NOTICE: 199 with **TYPE 2** cylinder head only.

The following parts have changed. (Interchangeable as a set)

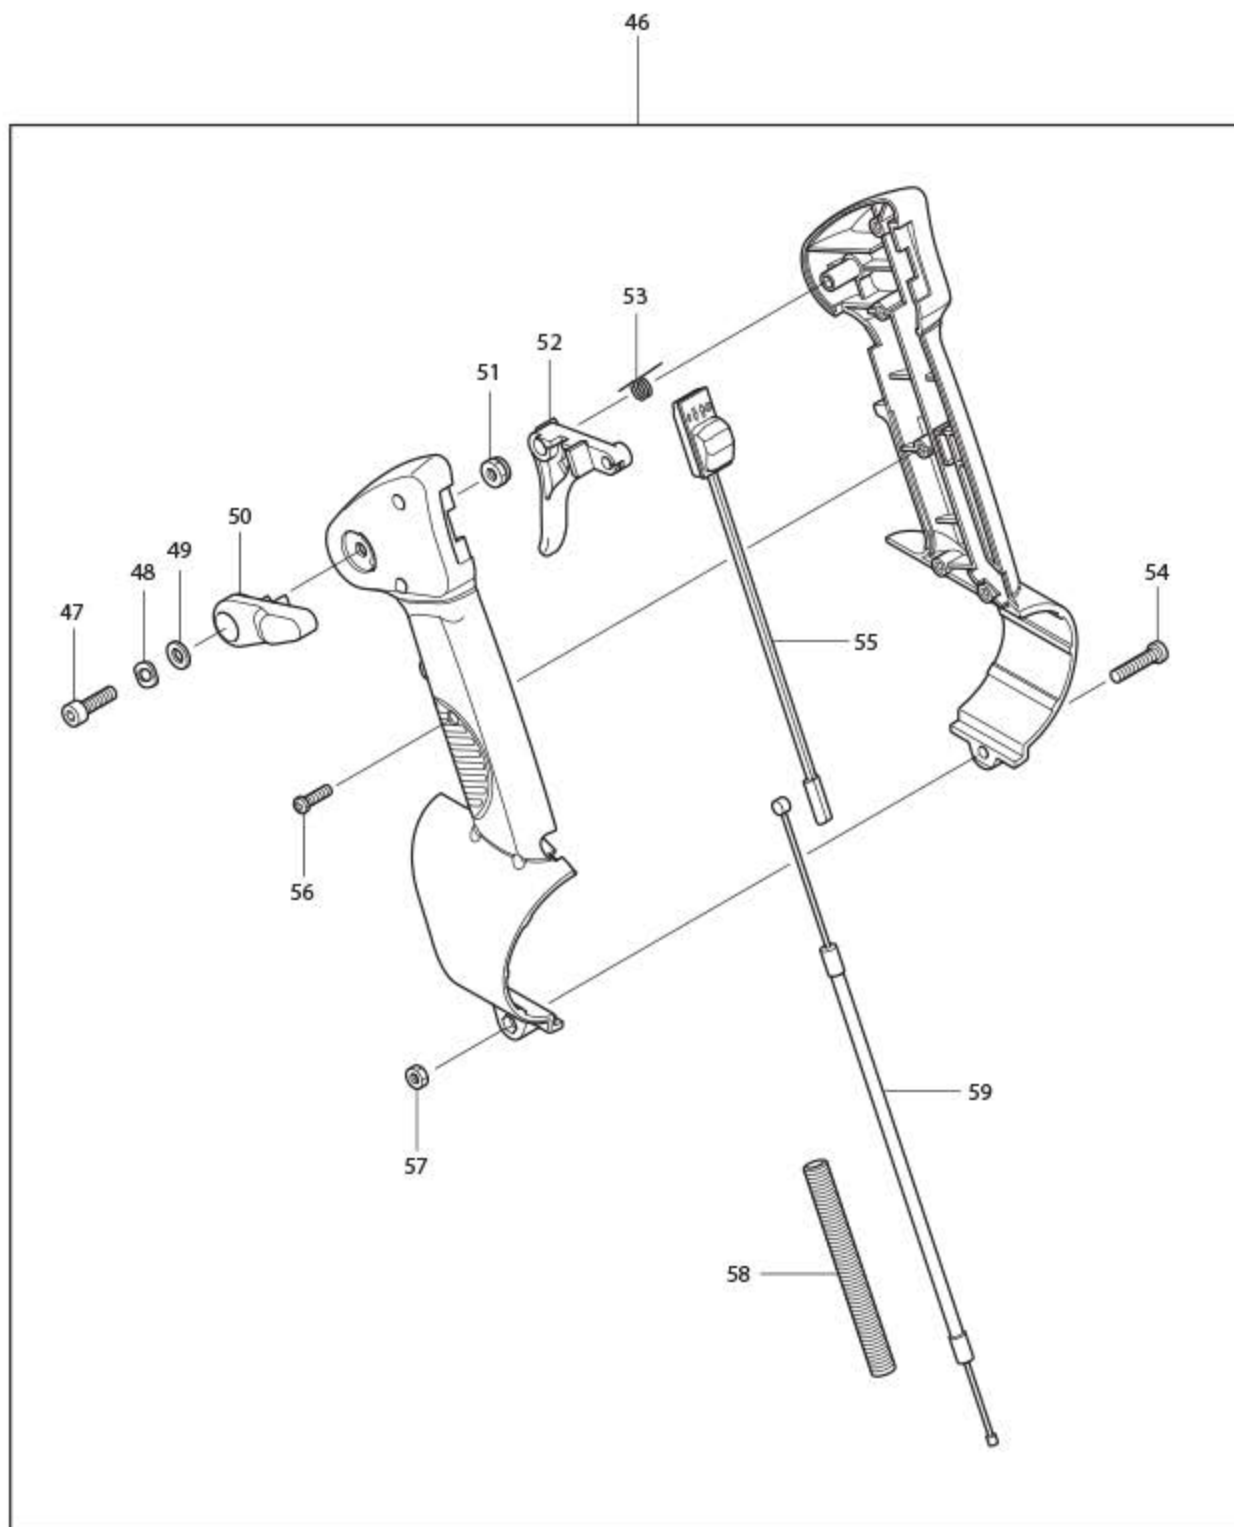
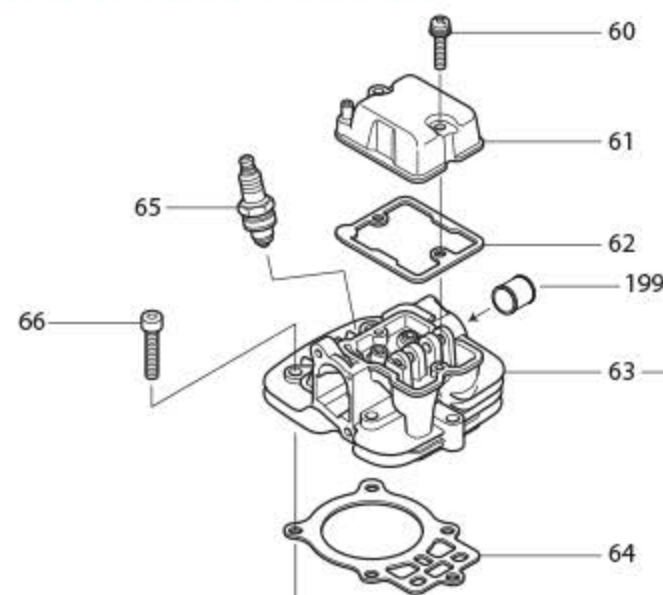
Prior to Jan 2011

Implemented Jan 2011

TYPE 2 Cylinder Head
NOTICE: Do not connect tube to port on insulator.

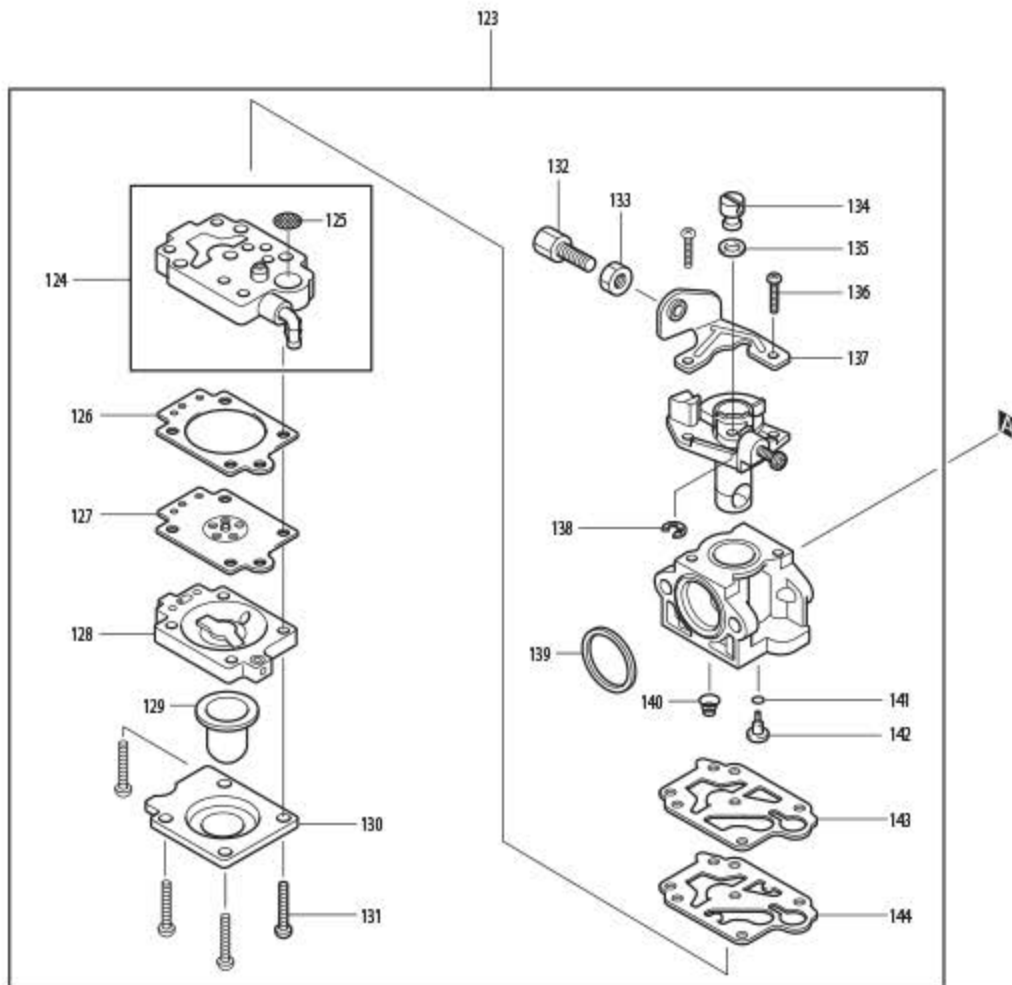
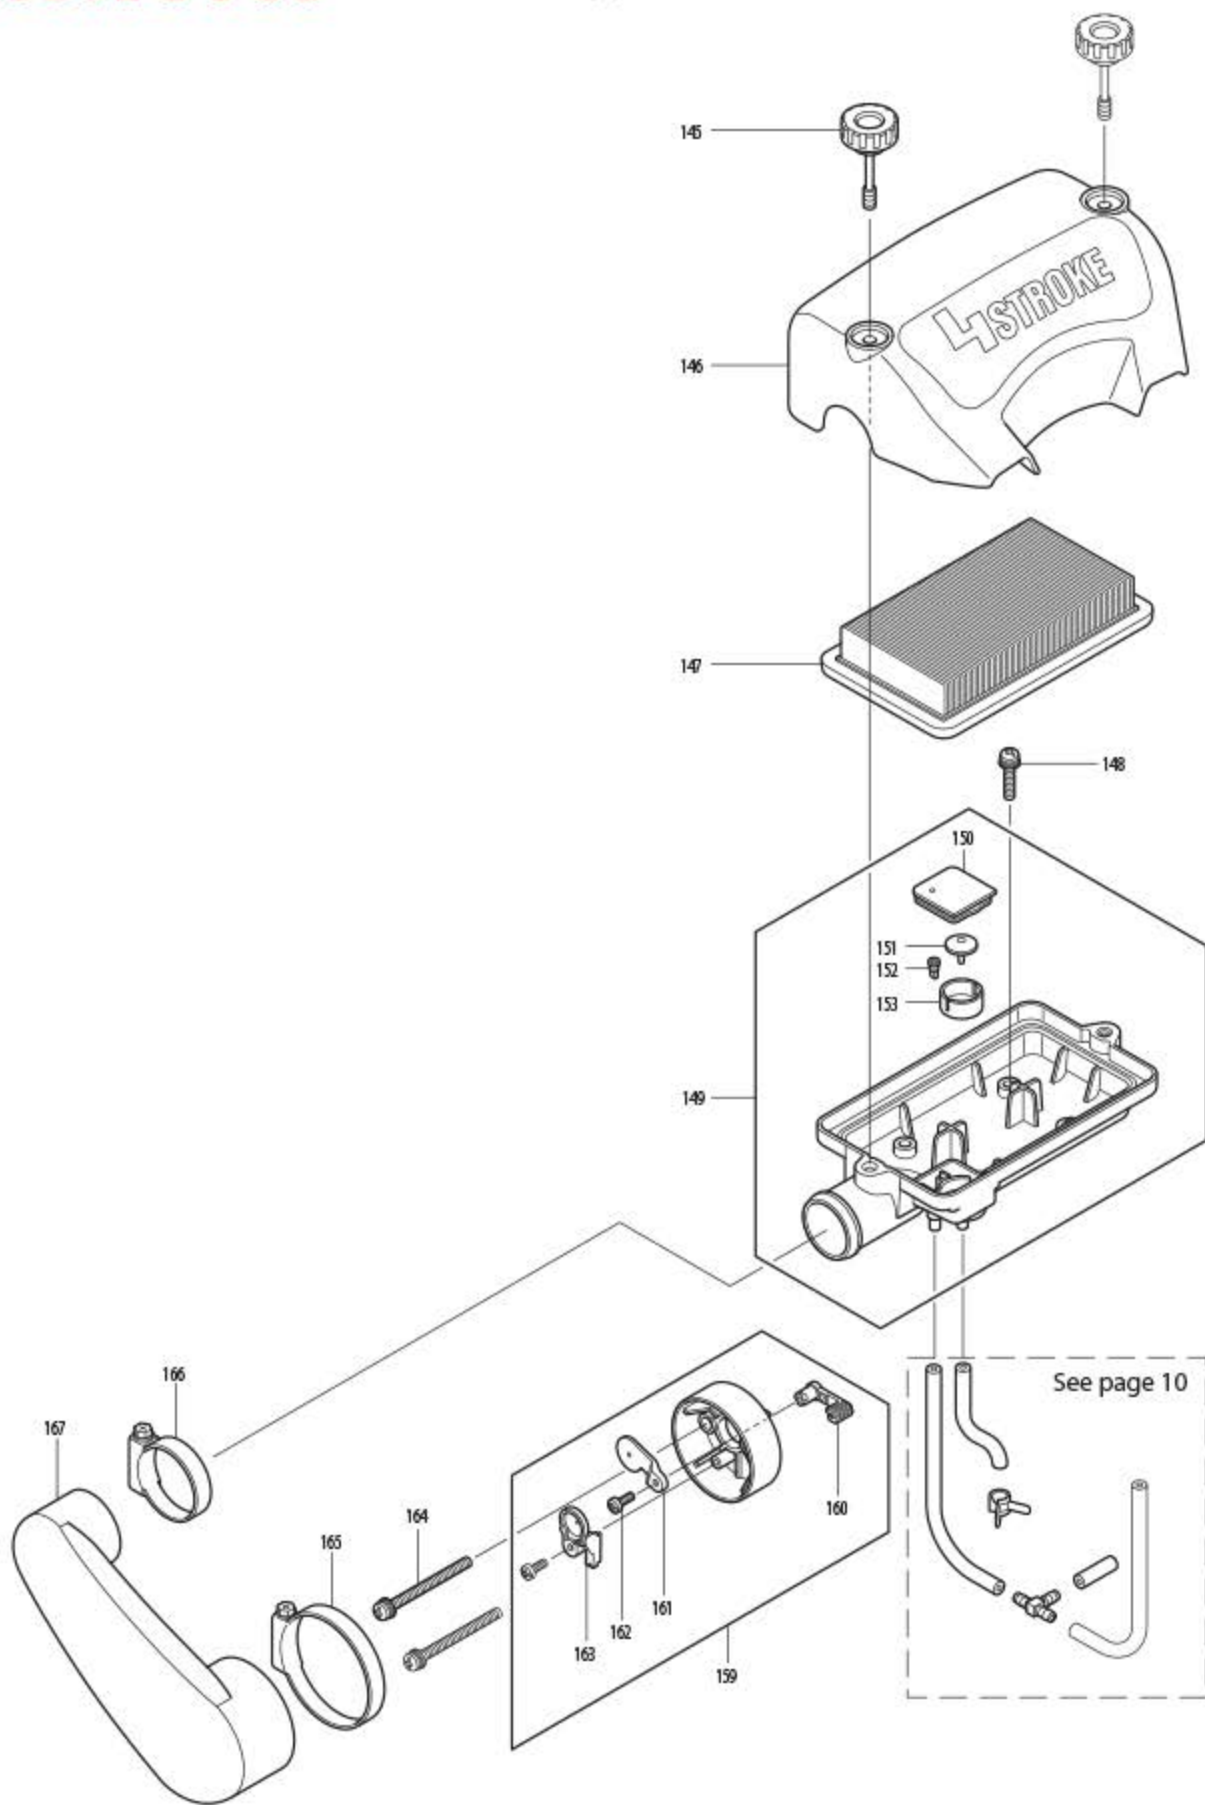
Reference Service Note
SN19.

TYPE 1 - OIL TUBE ASSEMBLY

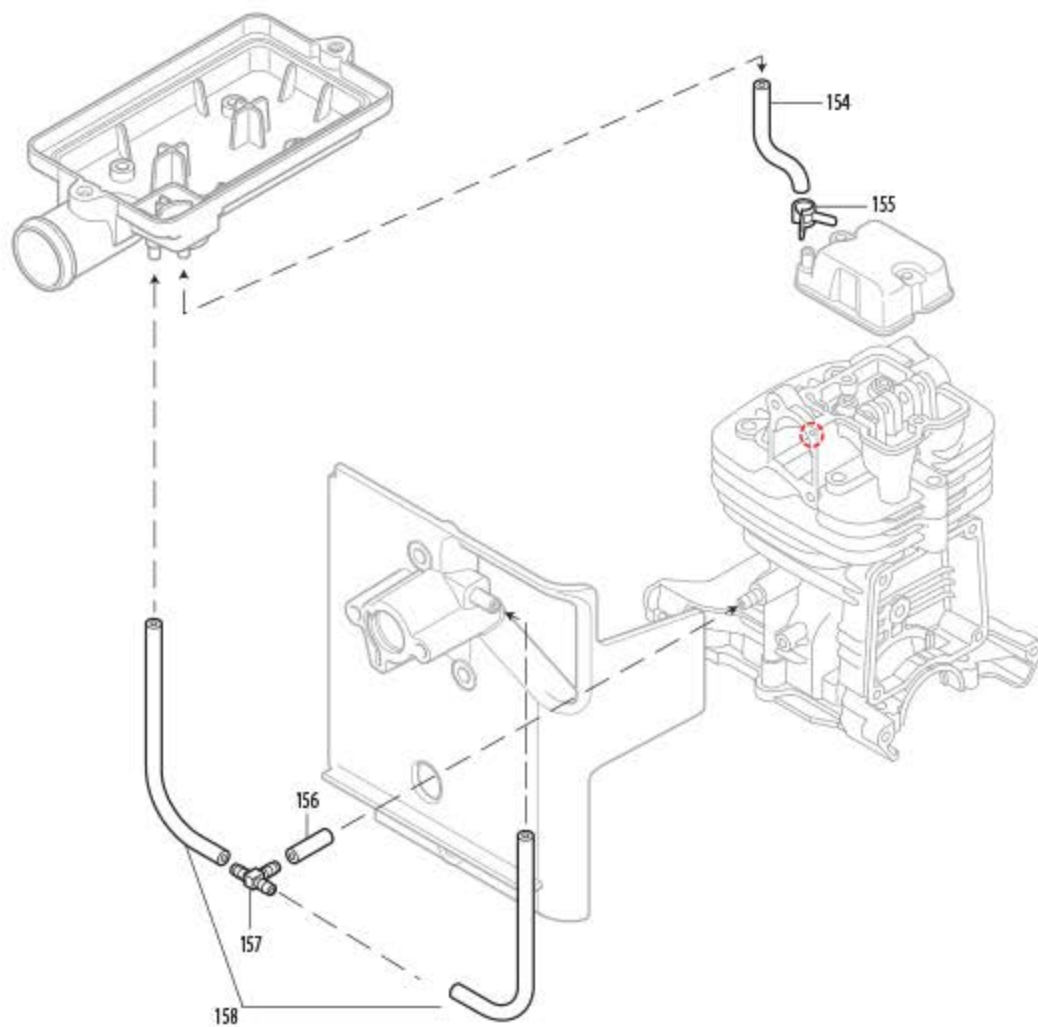
TYPE 1

Oil return passage here.

**TYPE 2 (Page 11)**

modified

Oil return passage is added here.

(Spacer Fig No. 199)

Oil return passage is eliminated.
